Product Change Notice (PCN)

PCN Number: **PCN-0451201R-02**

Product(s) Affected: **PJ-056**

PREVIOUS CUI DEVICES DETAIL / IMAGE	NEW CUI DEVICES DETAIL / IMAGE

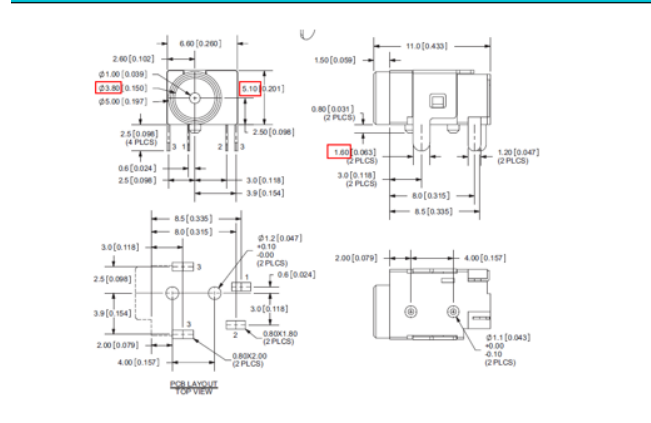
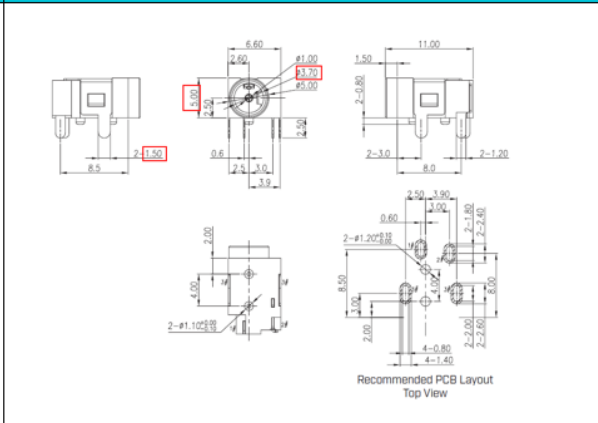
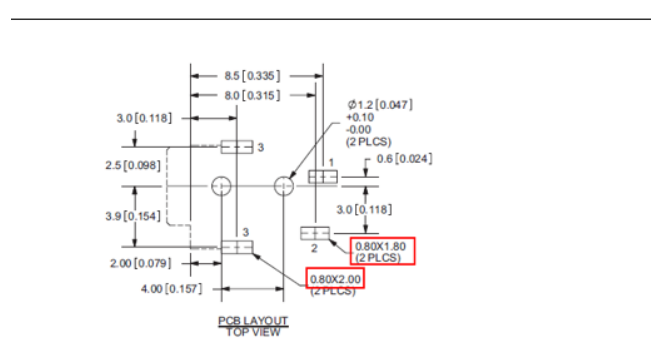
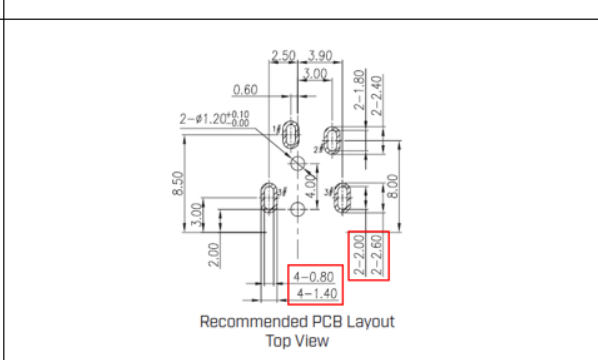
Description of Change: **Minor Housing and Material Difference. See image Below**

PREVIOUS CUI DEVICE'S DETAIL / IMAGE			NEW CUI DEVICE'S DETAIL / IMAGE		
	MATERIAL	PLATING			
center pin	brass	tin			
terminal 1	brass	tin			
terminal 2	copper alloy	tin			
terminal 3	copper alloy	tin			
plastic	PA66

DESCRIPTION	MATERIAL	PLATING/COLOR
terminal 1	brass	tin
terminal 2	copper alloy	tin
terminal 3	copper alloy	tin
housing	PBT (UL94V-0)	black
